# Access Compliance Report

## Public Rights-of-Way

### (Curb Ramps)

Intersection ID: 28130	Main Street: PORTMARNOCK_CT	Cross Street: TOM_SHORT_RD	Location: SW
ADA ID: ABEA23D7D10B	Ramp Type: PerpDiag	Initial Pass/Fail: Fail	Overall Compliance: No
Severity Score: 8.75			
Codes/Mitigation Info/Possible Solution		Field Measurements/Component Compliance

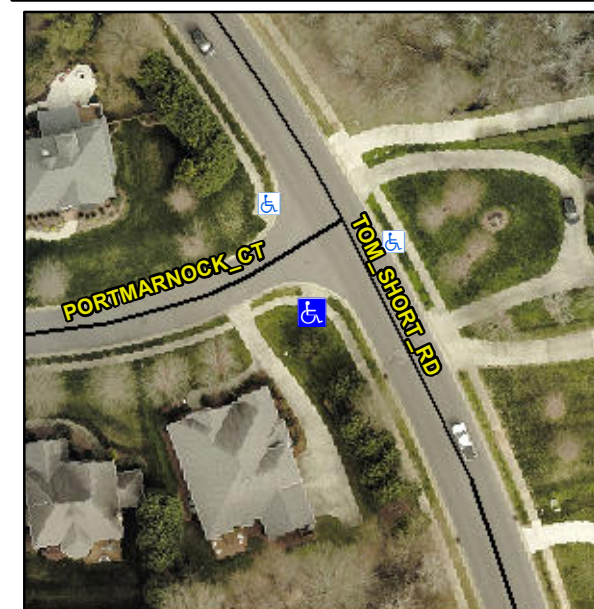
**Not Found, R304.5.1**

Compliance	Description	Data	Compliance	Description	Data
N/A	Ramp Length (in)	120.0	Yes	Ramp Slope (%)	7.3
No	Ramp Width (in)	36.0	Yes	Ramp XSlope (%)	1.2
N/A	Flare Type LT	N/A	N/A	Flare Type RT	N/A
N/A	Flare Slope LT (%)	N/A	N/A	Flare Slope RT (%)	N/A
N/A	Flare Traversable LT?	N/A	N/A	Flare Traversable RT?	N/A
N/A	Landing Length (in)	N/A	N/A	DWS Provided?	N/A
N/A	Landing Width (in)	N/A	N/A	DWS Contrast?	N/A
N/A	Landing Slope (%)	N/A	N/A	DWS Length (in)	N/A
N/A	Landing X Slope (%)	N/A	N/A	DWS Full Width?	N/A
N/A	Landing Curb? (Y/N)	N/A	N/A	DWS Offset (in)	N/A
N/A	Shared Landing?	N/A			
N/A	Gutter Ponding?	N/A	N/A	Gutter Slope (%)	N/A
N/A	Gutter Lip Ht (in)	N/A	N/A	Gutter X Slope (%)	N/A
N/A	Painted X Walk1?	No	N/A	Painted X Walk2?	No
	X Walk 1 Direction	To NE		X Walk 2 Direction	To NW
N/A	X Walk 1 Width (in)	N/A	N/A	X Walk 2 Width (in)	N/A
	X Walk 1 Slope (%)	1.6		X Walk 2 Slope (%)	2.2
	X Walk 1 X Slope (%)	2.3		X Walk 2 X Slope (%)	1.7

**Remove & Replace Curb Ramp With Two New Directional Ramps or Equivalent.**
